Workman® 3000 and 4000 Series Vehicles

Subject: Hydraulic Pump Pulley failure.

Ref: 08-02 Copyright[®], 1997. The Toro Company

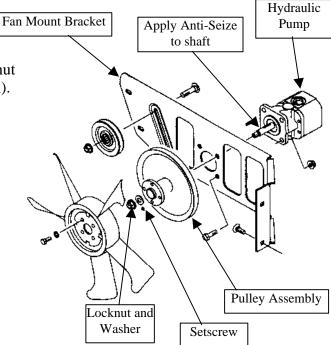
The fit of the Pulley on the Hydraulic Pump Shaft may allow enough movement between the parts during operation to promote keyway damage. A setscrew has been added to the hub directly over the keyway on all replacement pulleys to control movement and prevent failure.

Parts listed below are available through your local Toro distributor. Setscrew (3245-31) must be ordered separately. Installation instructions are included with this bulletin.

- 1. Install parts as shown.
- 2. Apply anti-seize or equivalent to shaft of pump before installing pulley.
- 3. After installing key and pulley, tighten locknut to a torque of 130-160 in/lb (150-184 KgCm).
- 4. Tighten setscrew to a torque of 27-32 in/lb (32-36 KgCm).
- 5. Install pump suction line, then fill hydraulic pump through pressure port with clean hydraulic oil.
- 6. After installing the pump and connecting hydraulic lines, adjust belt tension (Refer to Service Manual engine section for proper tension specification). Start the engine and operate at idle speed until air is out of hydraulic system.
- 7. Stop the engine and check oil level in transaxle. Add oil (Dexron II or III) if necessary.
